# CAUI-4 Ad hoc

Ryan Latchman, Mindspeed

# Transmit equalizer

# Transmit equalization characterization

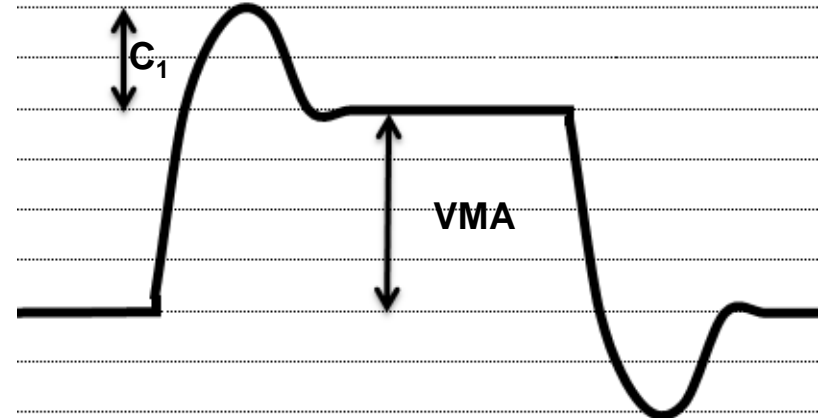
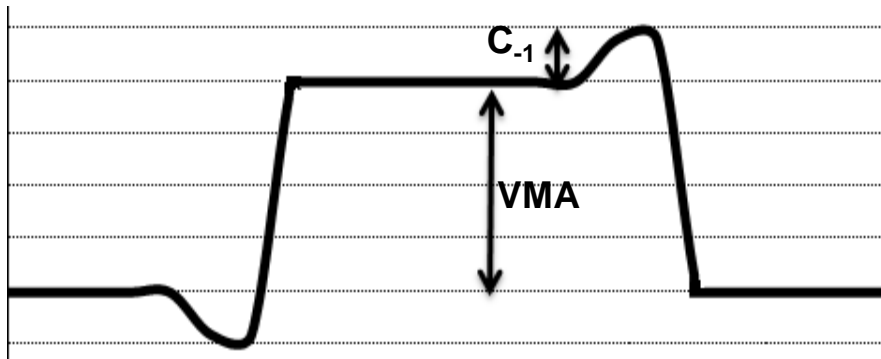
- Measure VMA per 86A.5.3.5 using square wave or PRBS9 defined in 86-11 using a test system with a fourth-order Bessel-Thomson low-pass response with 33 GHz 3 dB bandwidth
- Set post cursor equalization to zero setting. Measure pre-cursor amplitude defined as the peak amplitude before a transition. Define  $C_0$ ,  $C_{-1}$  as normalized main tap, and pre cursor values per equations A and B. Calculate pre cursor value for each precursor setting using equation C
- Set pre cursor equalization to zero setting. Measure post-cursor amplitude defined as the peak amplitude after a transition. Define  $C_0$ ,  $C_1$  as normalized main tap, and post cursor values per equations D and E. Calculate post cursor value for each precursor setting using equation F

Equation A  $|C_0| + |C_{-1}| = 1$

Equation B  $VMA = (|C_0| - |C_{-1}|) \times Amplitude_{p-p}$

Equation C  $Preursor\_value(C_{-1}) = 20 * LOG_{10} \left( \frac{1}{C_0 - C_{-1}} \right)$

Equation D  $|C_0| + |C_1| = 1$

Equation E  $VMA = (|C_0| - |C_1|) \times Amplitude_{p-p}$

Equation F  $Postcursor\_value(C_1) = 20 * LOG_{10} \left( \frac{1}{C_0 - C_1} \right)$

Figure 83D-7—Transmitter eye mask

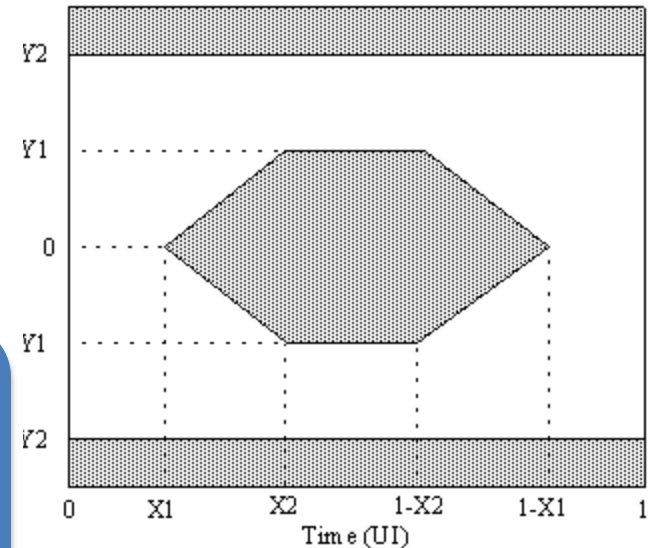
- The eye mask shown in is defined at a BER of  $10^{-15}$ , using the methodology described in TBD. Transmitter equalizer may be adjusted for optimum mask results.

- Transmit output waveform in CAUI-4 chip-to-chip are measured using a fourth-order Bessel-Thomson low-pass filter response with 33 GHz 3 dB bandwidth. X1 is measured using the methodology described in 83D.3.1.4 where  $X1 = T/2$ . Y2 is measured using the methodology described in 83D.3.1.1. Y1 is measured using the following procedure using a PRBS9 waveform:

- Capture the PRBS9 pattern using a clock recovery unit with 3 dB tracking bandwidth of 10 MHz and maximum peaking of 0.1 dB and a minimum sampling rate of 3 samples per bit. Collect sufficient samples equivalent to at least 4 million bits to allow for construction of a normalized cumulative distribution function (CDF) to a probability of  $10^{-6}$  without extrapolation.

- Use the differential signal from step 1 to construct the CDF of the signal amplitude at X2, midpoint (0.5) and 1-X2, for both logic 1 (CDF1) and logic 0 (CDF0), as a distance from the center of the eye. Calculate the eye height for each point (EH6) as the difference in amplitude between CDF1 and CDF0 with a value of  $10^{-6}$ . CDF0 and CDF1 are calculated as the cumulative sum of histograms of the amplitude at the top and bottom of the eye normalized by the total number of sampled bits. For a well balanced number of ones and zeros the maximum value for CDF0 and CDF1 will be 0.5.

- Apply the Dual-Dirac and tail fitting techniques to CDF1 and CDF0 to estimate the noise at X2, 0.5 and 1-X2 points. Calculate the best linear fit in Q-scale over the range of probabilities of  $10^{-4}$  and  $10^{-6}$  of CDF1 and CDF0 to yield relative noise one (RN1) and relative noise zero (RN0). The eye height for plotting against the eye mask at X2, 0.5, and 1-X2 is then given by

- $EH15 = EH6 - 3.19 \times (RN0 + RN)$
- where
  - *EH15 peak is the eye height extrapolated to  $10^{-15}$  probability*
  - *EH6 is the eye height at  $10^{-6}$  probability*
